Date: November 30, 2023
To: All Vendors
Subject: Addendum #2

**REFERENCE: B014-24 Re-Bid BPUB Downtown Wastewater Improvements-ARPA
Project 1**

Project:	Brownsville PUB – Downtown Wastewater Improvements ARPA Project 1 BPUB Bid No. B014-24	Addendum Date:	November 30, 2023
From:	Javier A. Esquivel, PE	Project No.:	BPUB2200025.01

ADDENDUM No. 2

SHEET
CA07

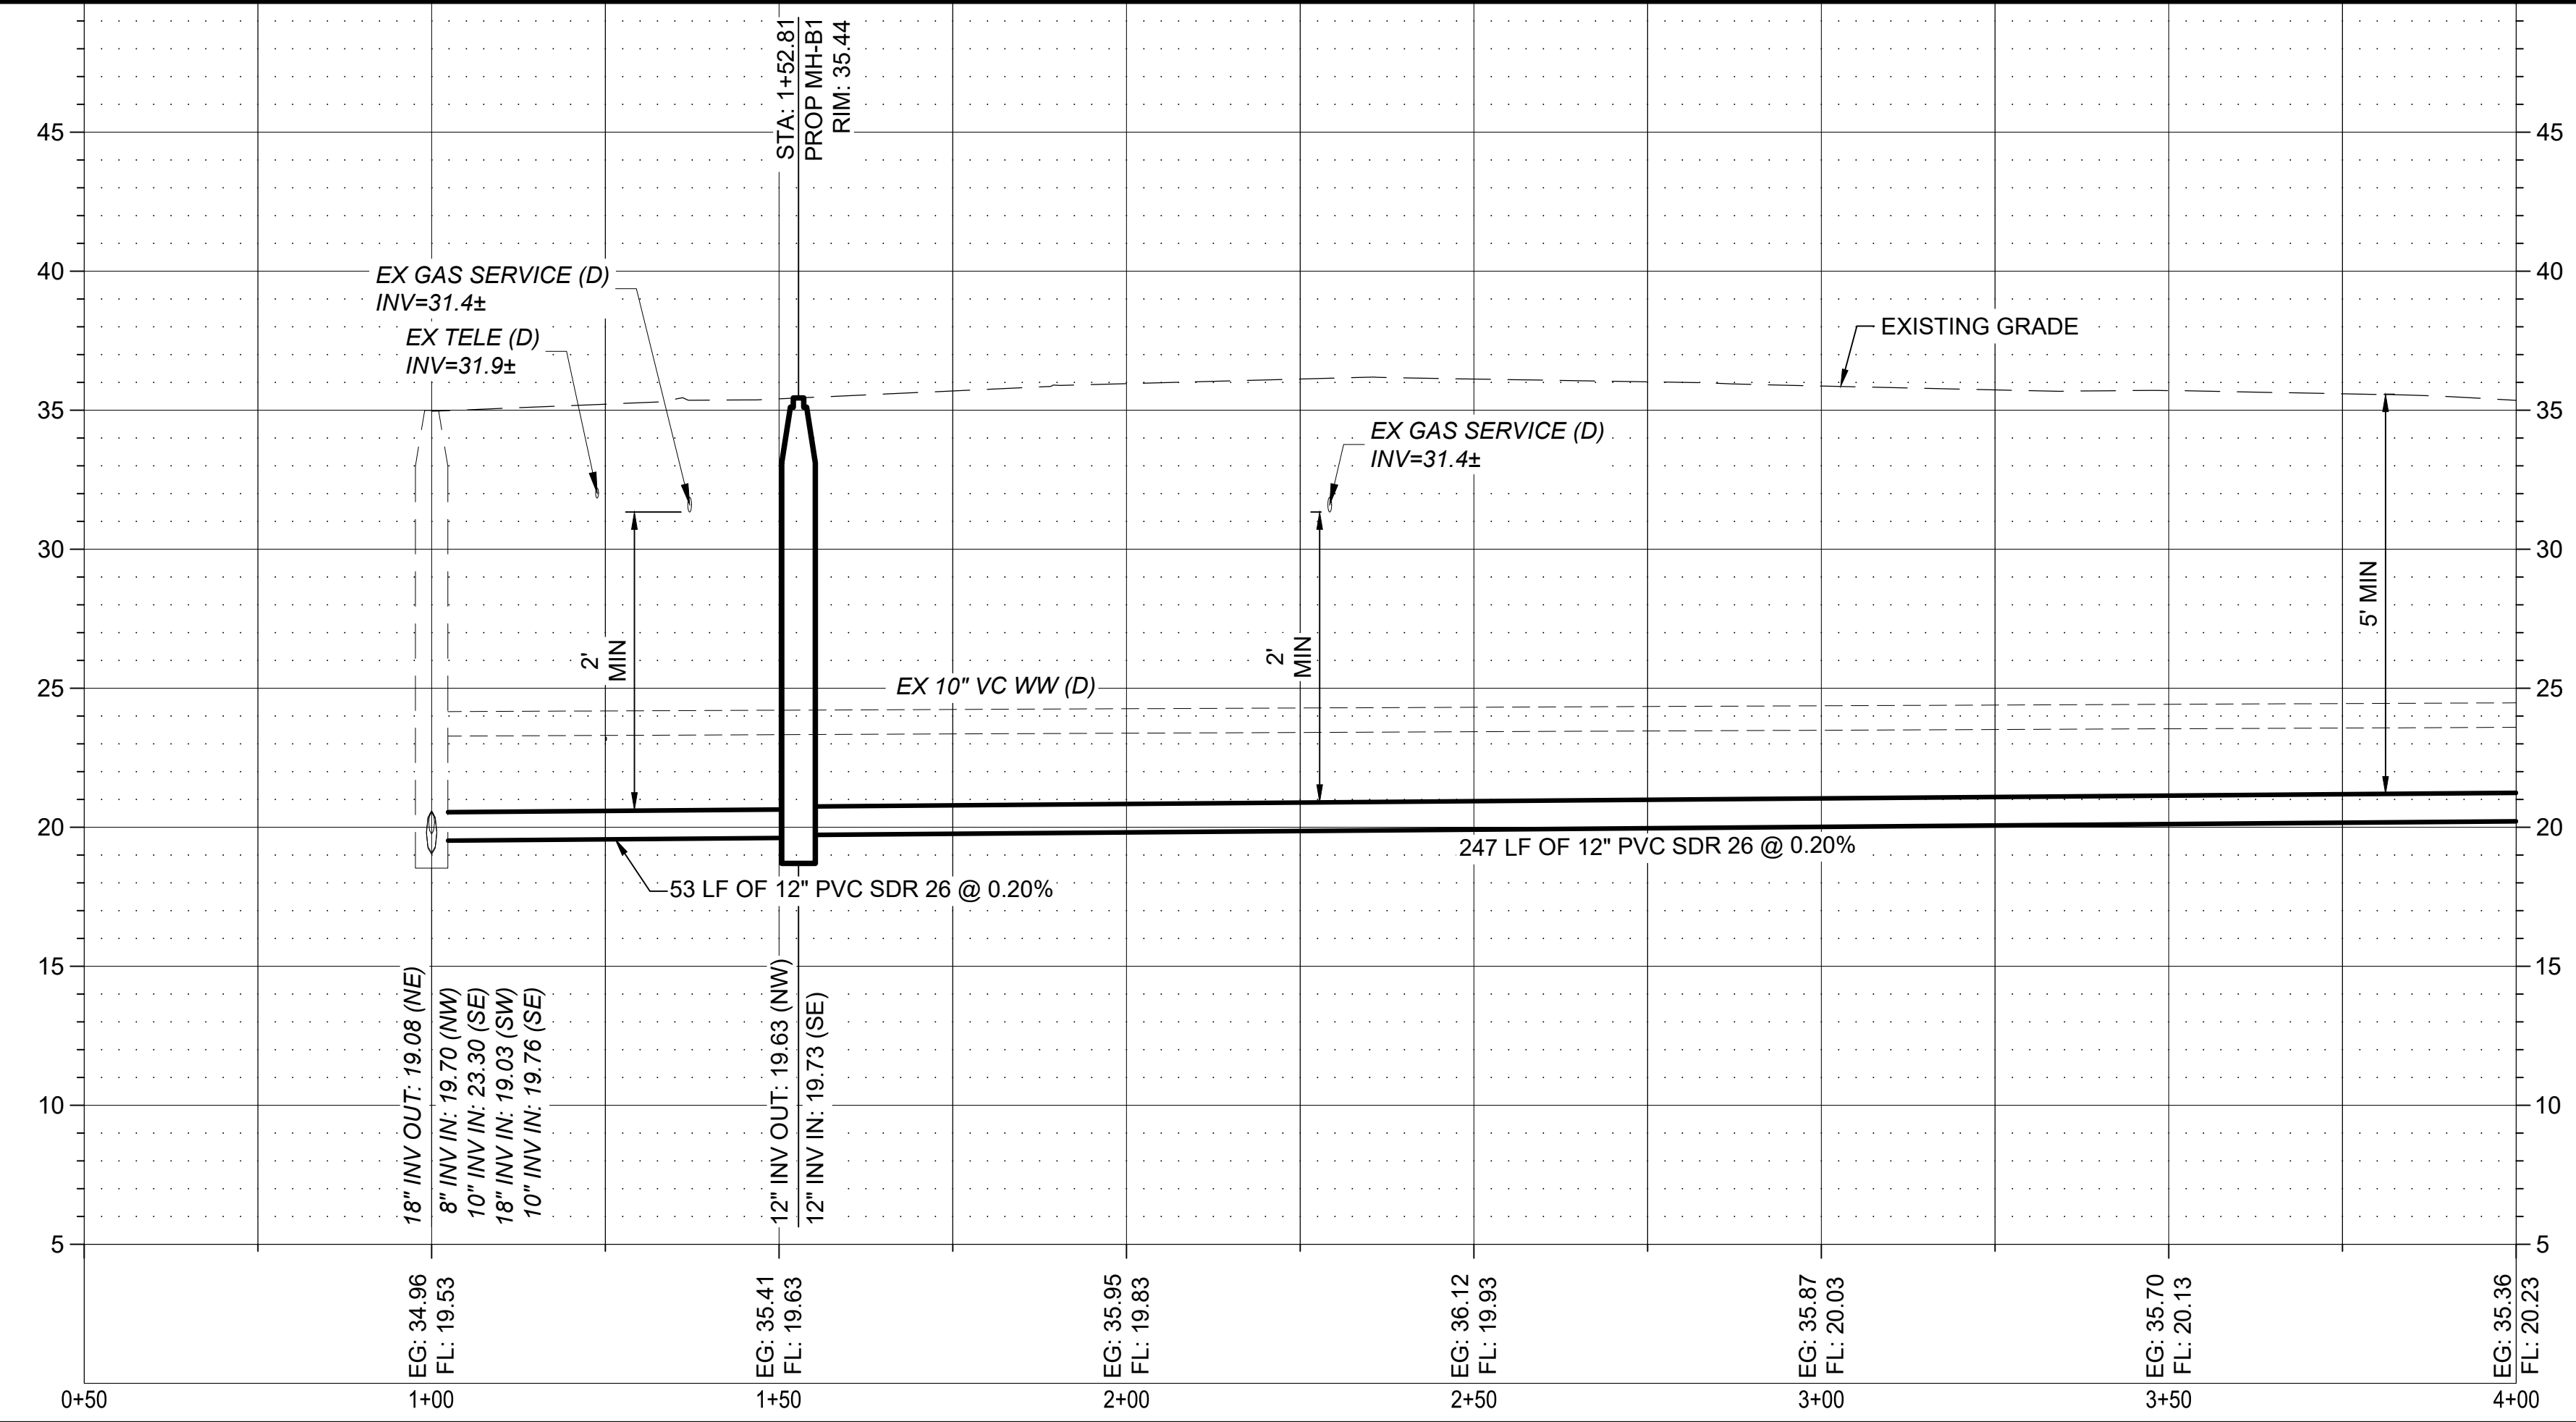
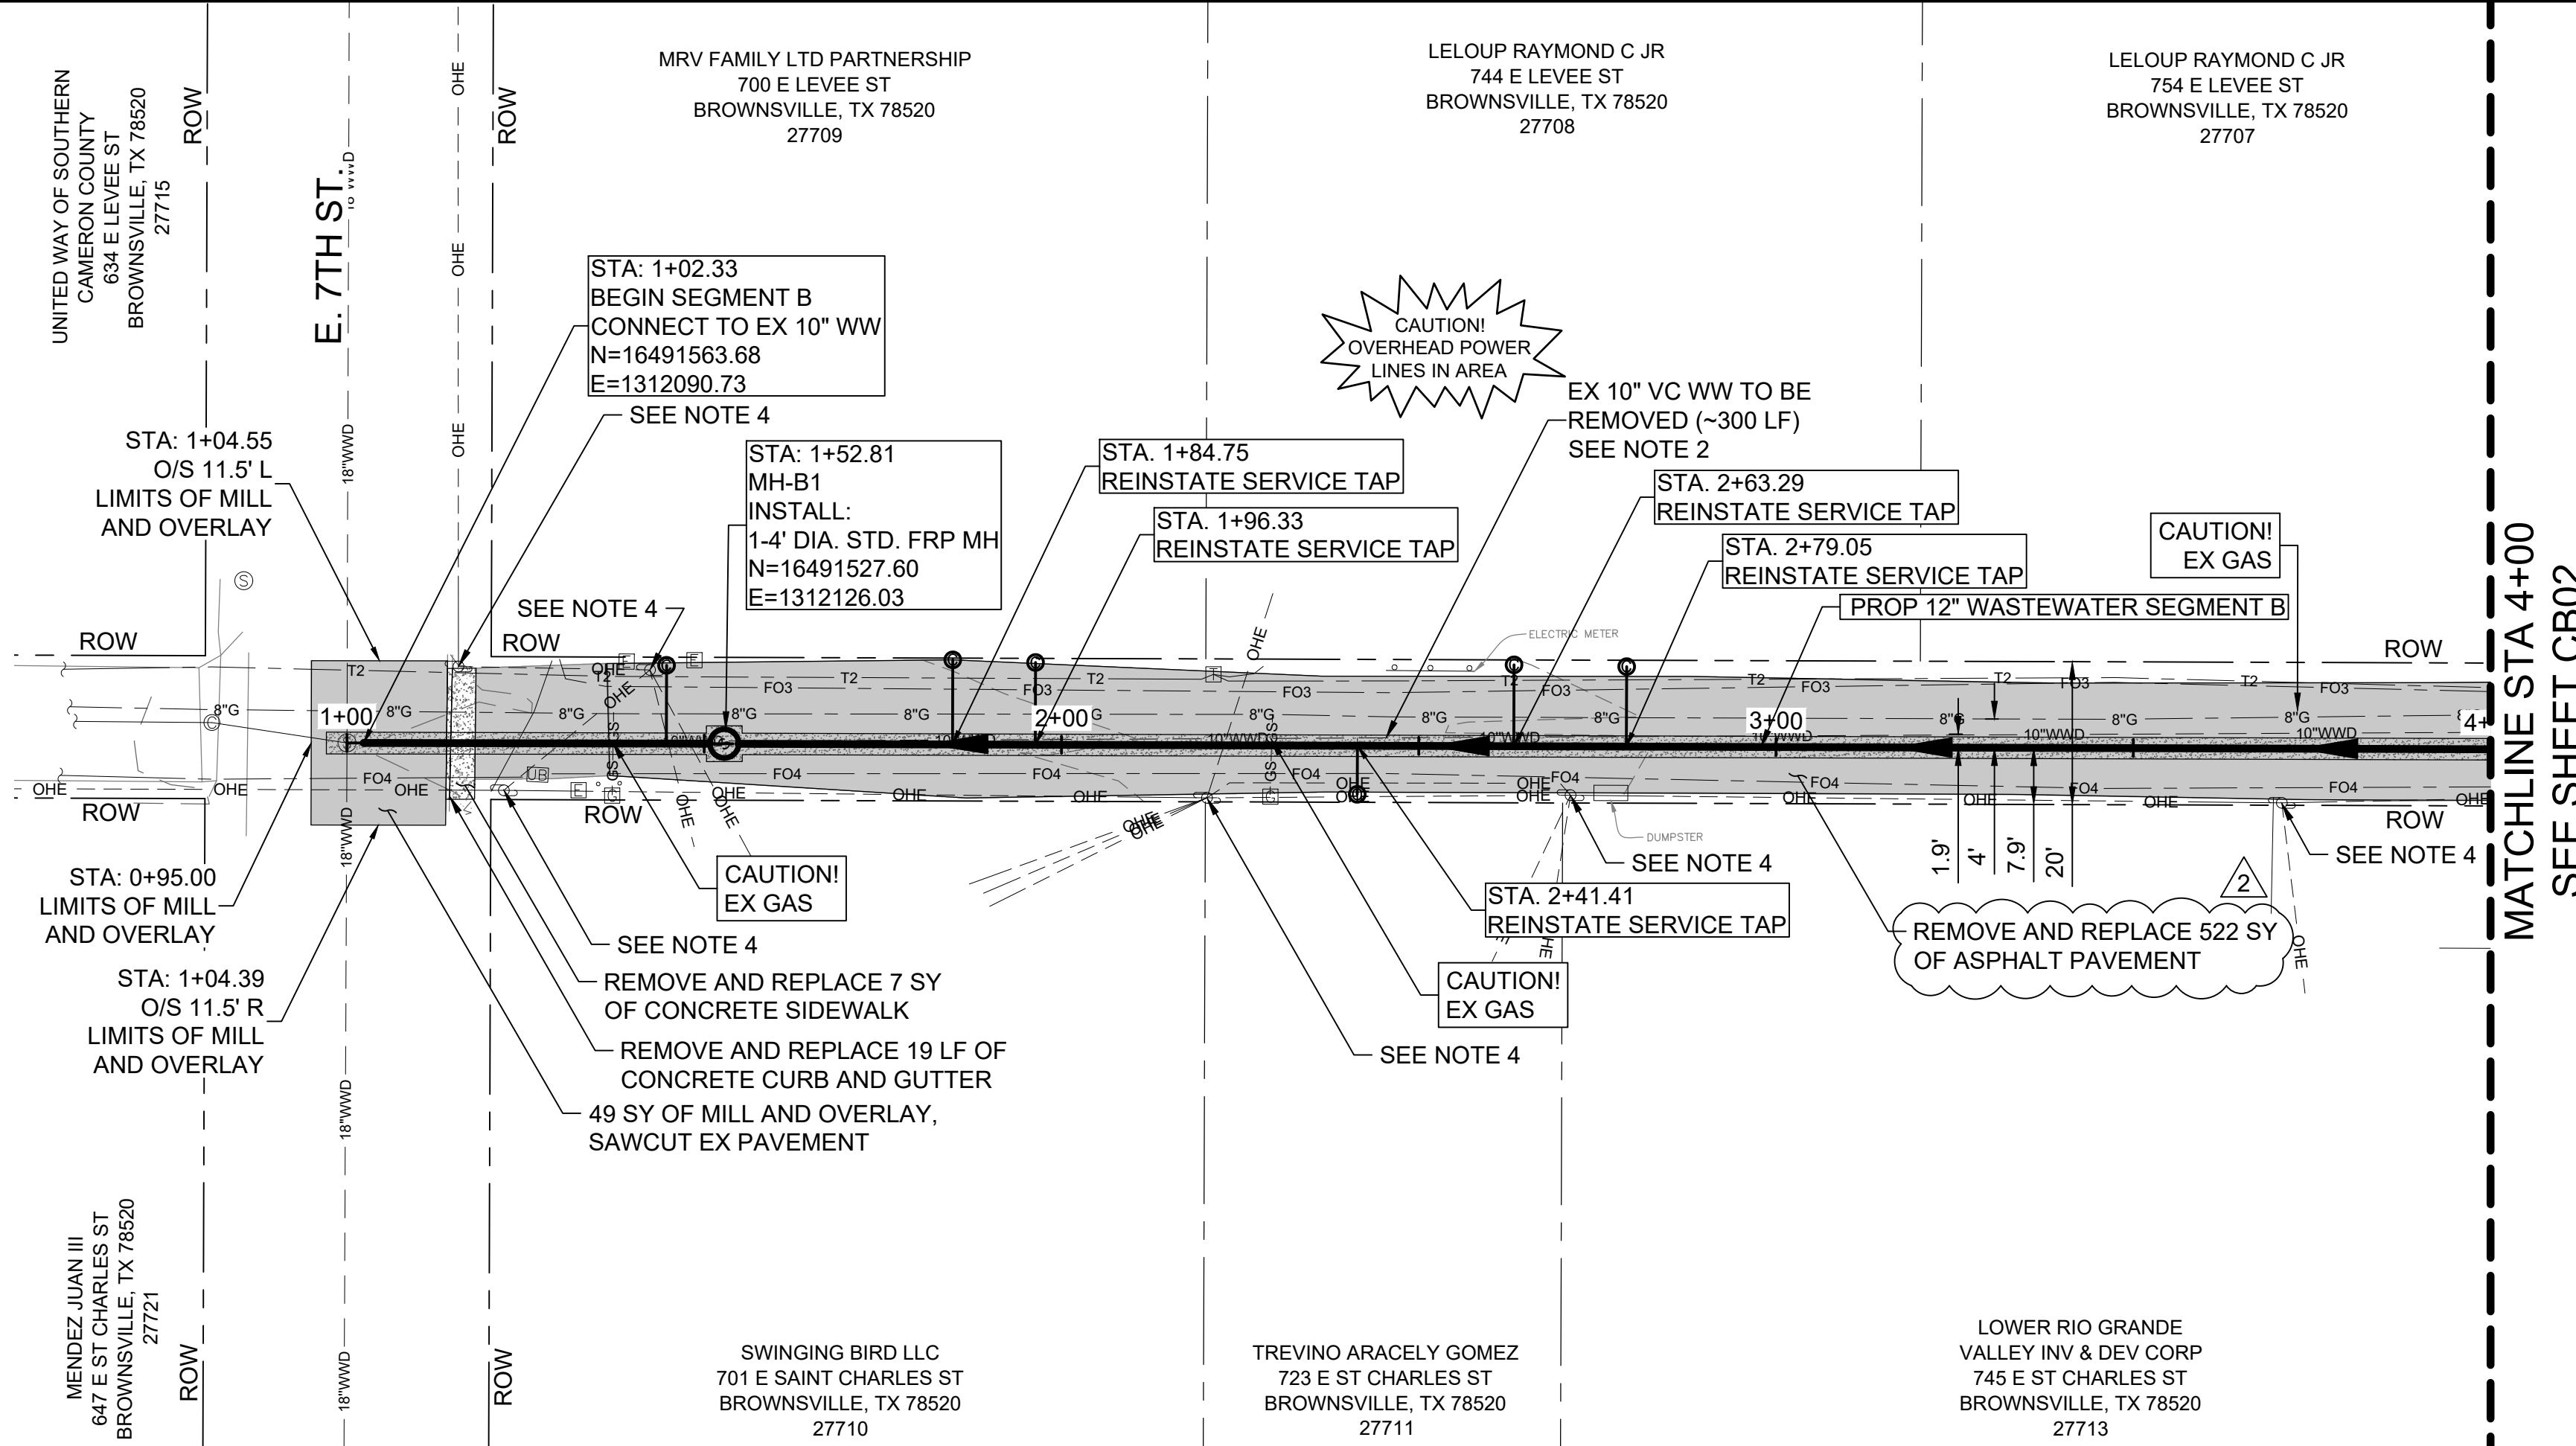
1. Revisions to Surface Restoration in the Alleys.
 - Segment A: Replace Mill and Overlay (2”) with full depth concrete asphalt pavement removal and replacement.
 - Segment B: Replace Mill and Overlay (2”) with full depth asphalt pavement removal and replacement.
 - Segment C: Replace Mill and Overlay (2”) with full depth asphalt pavement removal and replacement.

3. Plan Sheets: The following plan sheets were modified to update surface restorations CA02, CA03, CA04, CA05, CA06, CA07, CB01, CB02, CB03, CC02, CC03, CC04, and CC05.
